# Access Compliance Report

## Public Rights-of-Way

### (Curb Ramps)

Intersection ID: N/A	Main Street: DALLAS_BAY_RD	Cross Street: HAMILTON_BRIDGE_RD	Location: NW
ADA ID: 8AEE1A054E7A	Ramp Type: Perp	Initial Pass/Fail: Fail	Overall Compliance: No
			Severity Score: 21.25

#### Codes/Mitigation Info/Possible Solution

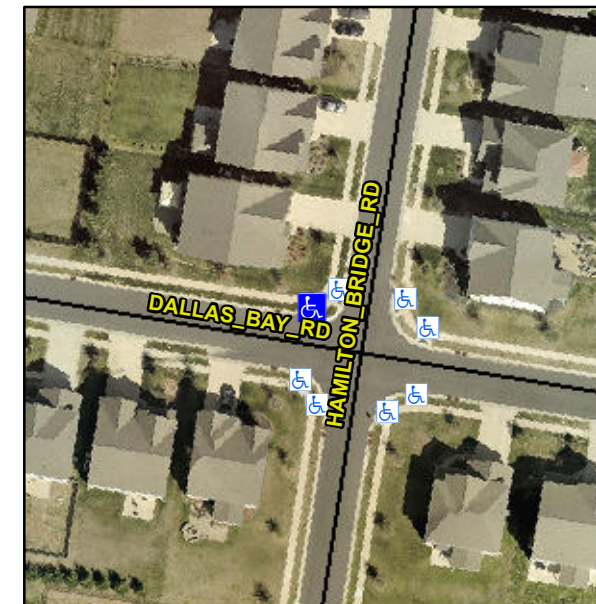
**Not Found, R304.5.1, R304.2.2**

Compliance	Description	Data	Compliance	Description	Data
N/A	Ramp Length (in)	47.0	No	Ramp Slope (%)	9.1
No	Ramp Width (in)	47.0	Yes	Ramp XSlope (%)	0.5
N/A	Flare Type LT	N/A	N/A	Flare Type RT	N/A
N/A	Flare Slope LT (%)	N/A	N/A	Flare Slope RT (%)	N/A
N/A	Flare Traversable LT?	N/A	N/A	Flare Traversable RT?	N/A
N/A	Landing Length (in)	N/A	N/A	DWS Provided?	N/A
N/A	Landing Width (in)	N/A	N/A	DWS Contrast?	N/A
N/A	Landing Slope (%)	N/A	N/A	DWS Length (in)	N/A
N/A	Landing X Slope (%)	N/A	N/A	DWS Full Width?	N/A
N/A	Landing Curb? (Y/N)	N/A	N/A	DWS Offset (in)	N/A
N/A	Shared Landing?	N/A			
N/A	Gutter Ponding?	N/A	N/A	Gutter Slope (%)	N/A
N/A	Gutter Lip Ht (in)	0.5	N/A	Gutter X Slope (%)	N/A
N/A	Painted X Walk1?	No	N/A	Painted X Walk2?	N/A
	X Walk 1 Direction	To SW		X Walk 2 Direction	N/A
N/A	X Walk 1 Width (in)	N/A	N/A	X Walk 2 Width (in)	N/A
	X Walk 1 Slope (%)	1.6		X Walk 2 Slope (%)	N/A
	X Walk 1 X Slope (%)	1.2		X Walk 2 X Slope (%)	N/A

**Remove & Replace Entire Ramp.**
